NEW HORIZONS CREDIT UNION SUBDIVISION

APPLICATION NUMBER 8 DATE September 18, 2008
APPLICANT New Horizons Credit Union Subdivision
REQUEST Subdivision

DETAIL SITE PLAN

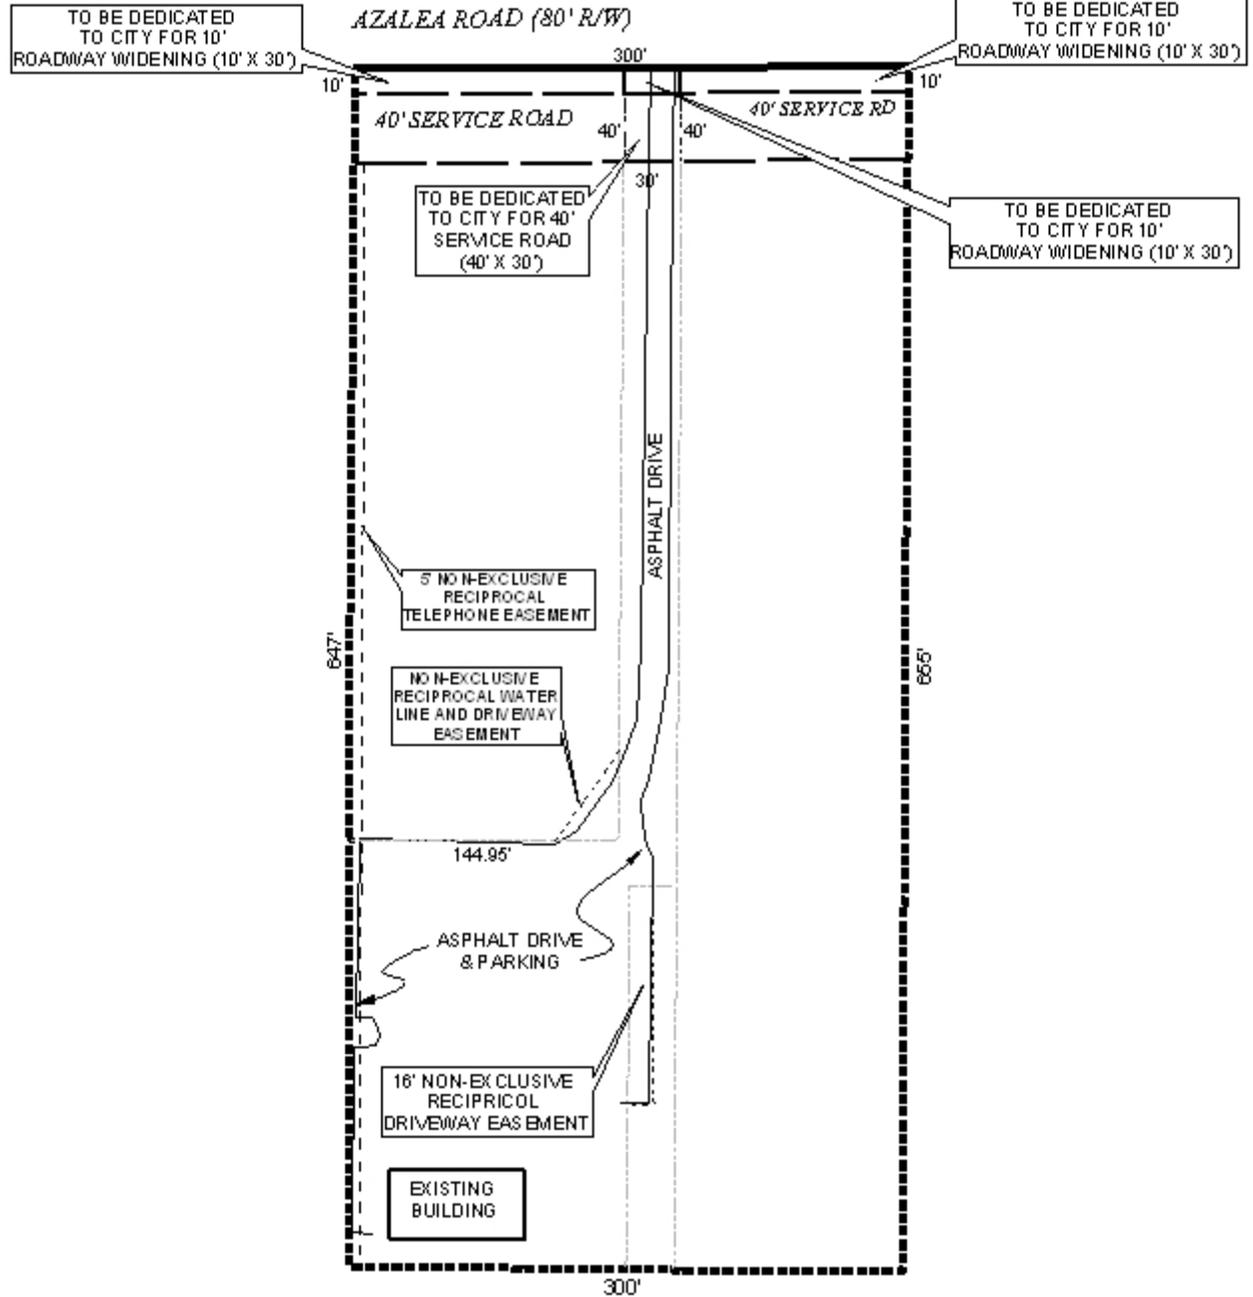
The site fronts Azalea Road, a proposed major street with 80' of right-of-way. However, the plat submitted by the applicant is inaccurate. It illustrates the proposed subdivision as being one whole lot with 300' of frontage onto Azalea Road. It also depicts a 40' service road, which begins 10' from the right-of-way. However, while the service road is labeled, it is illustrated as being part of the proposed lot. In addition, there appears to be an existing 25' driveway, which is not shown on the plat, extending through the service road to Azalea Road. This is especially confusing, since it is unclear what the applicant does and does not own. Therefore, this application should be held over to allow the applicant to revise the plat to accurately illustrate the existing and proposed parcel/lot boundaries.

There is no depiction of the minimum building setback line on the plat. If approved, this should be addressed prior to signing the final plat.

The plat meets the minimum size requirement for developments with access to public water and sewer. However, it is requested that the applicant revise the preliminary plat to label the lot with its size in square feet, or provide a table on the plat with the same information.

The applicant submitted a revised plat accurately illustrating the boundaries of the proposed subdivision. As mentioned earlier, there is a section (40' x 30') of an existing driveway which bisects the service road. In order to clear up the confusion, the applicant has offered to dedicate this section of property, along with the 10' widening strip for Hillcrest Road. This brings dedication to a total of 50', which includes the service road dedication as originally required.

The proposed lot is not labeled; thus, the plat should be revised to label the lot as "Lot 1."

- 1) Dedication of the 10' widening strip and the 40' x 30' section of driveway;*
- 2) Placement of a note on the final plat stating that the site is limited to one curb cut, with the size, location, and design to be approved by Traffic Engineering and conform to AASHTO standards;*
- 3) Depiction of the 25' minimum building setback line from Hillcrest Road on the final plat;*
- 4) Labeling of the lot with it's size in square feet, or the provision of a table on the plat with the same information;*
- 5) Labeling of the lot as "Lot 1"; and*
- 6) Placement of a note on the plat / site plan stating that the site must be developed in compliance with all local, state and Federal regulations regarding endangered, threatened or otherwise protected species.*
